UNITED STATES PATENT AND TRADEMARK OFFICE

APPLICATION NO.	FILING DATE	FIRST NAMED INVENTOR	ATTORNEY DOCKET NO.	CONFIRMATION NO.
09/471,829	12/23/1999	MASATSUGU HATANAKA	49481(551)	8004

Office Action Summary	Application No. 09/471,829	Applicant(s) HATANAKA ET AL.	
	Examiner Samuel A. Turner	Art Unit 2877	<i>an</i>

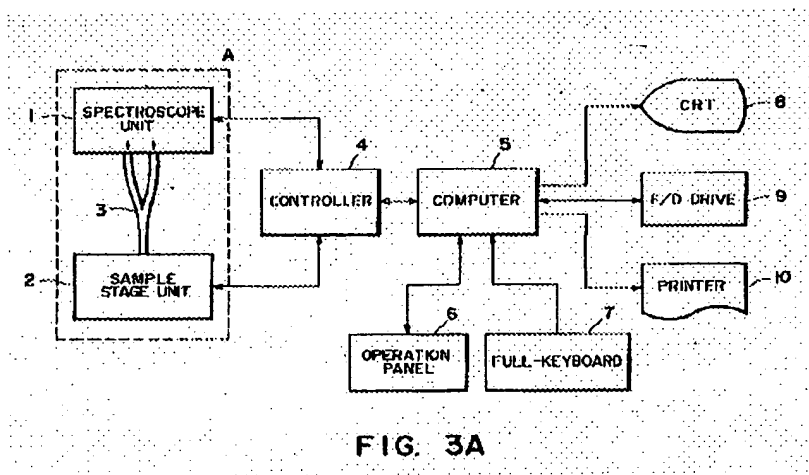
Claims 1 and 19 are rejected under 35 U.S.C. 102(b) as being clearly anticipated by Ban et al(4,787,749).

Ban et al teach a film thickness system comprising a light source(1a), at least one input and one output optical fiber(3) normal to the thin film, detector(1c), and computer(5). See figure 3A.

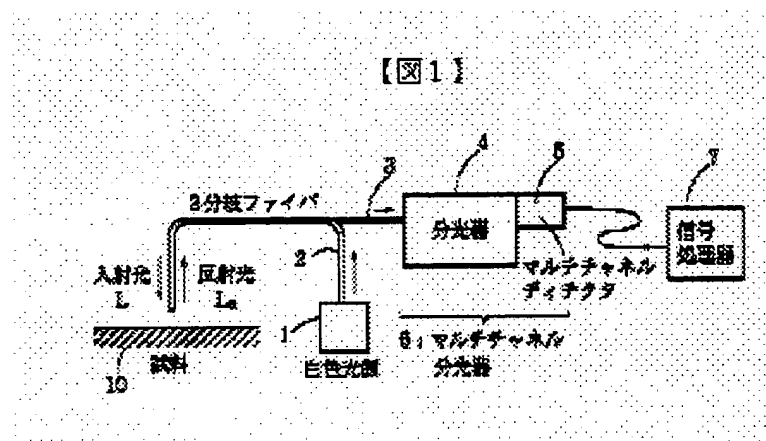
Claims 1, 7, 10, 19, and 20 are rejected under 35 U.S.C. 102(b) as being clearly anticipated by Shigeki et al(JP 07-294220).

Shigeki et al teach a light source(1), optical fiber(2) which is normal to the thin film, output fiber(3), spectroscope(4), detector(5), and processor(7). See figure 1.

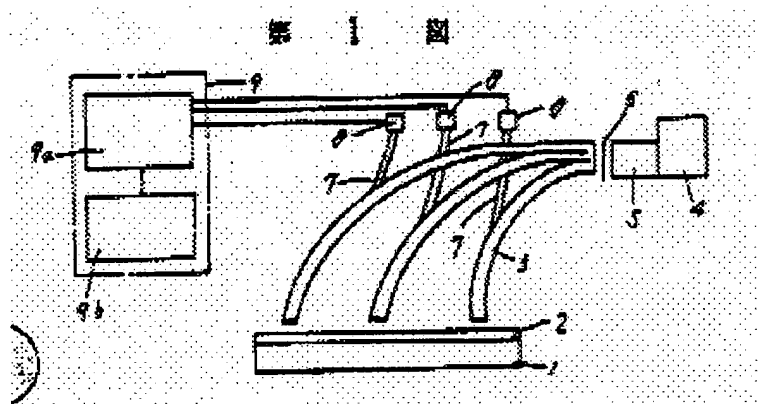
Claims 17, and 18 are rejected under 35 U.S.C. 103(a) as being unpatentable over Shigeki et al(JP 07-294220).

Shigeki does not teach the use of a robotic hand or relative location of the light receiving unit in regard to the outlet of the gate valve.

It would have been obvious to one of ordinary skill in the art at the time the invention was made locate the light receiving unit in any operable position since it has been held that rearranging parts of an invention involves only routine skill in the art. In re Japikse, 86 USPQ 70. As to the robot hand of claim 17, substrates are made in a clean room and not touched by human hands. The wafer is moved between deposition, exposure, and measurement by a conveyer such as a mechanical or robot arm.
